Subject: 15204 – Noncompliance Recall
A-Pillar Trim Replacement

Models: 2006-2008 Saab 9-5
VIN Range: 63500026 - 83512093

MODIFICATION INSTRUCTION

MI No. 855-2712	Date November 2008	9-5
Distr. US

Parts required

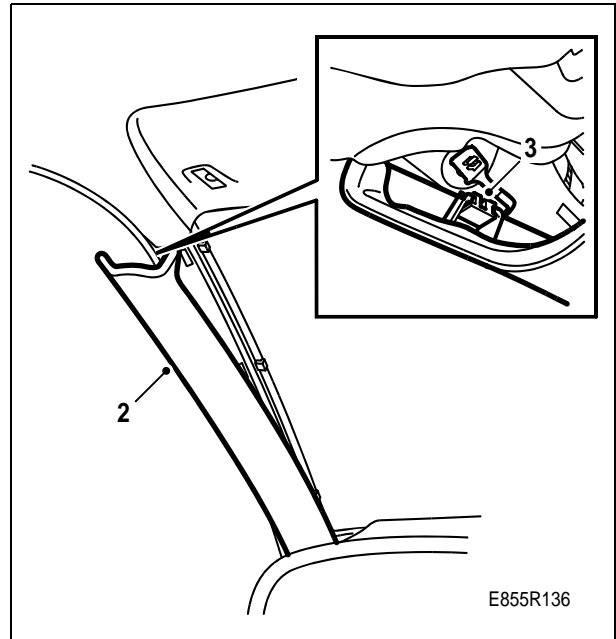
The A-pillar trim does not fulfil the FMVSS 201U legal requirement with regard to head protection.

12842653 A-pillar trim (left)

12842654 A-pillar trim (right)
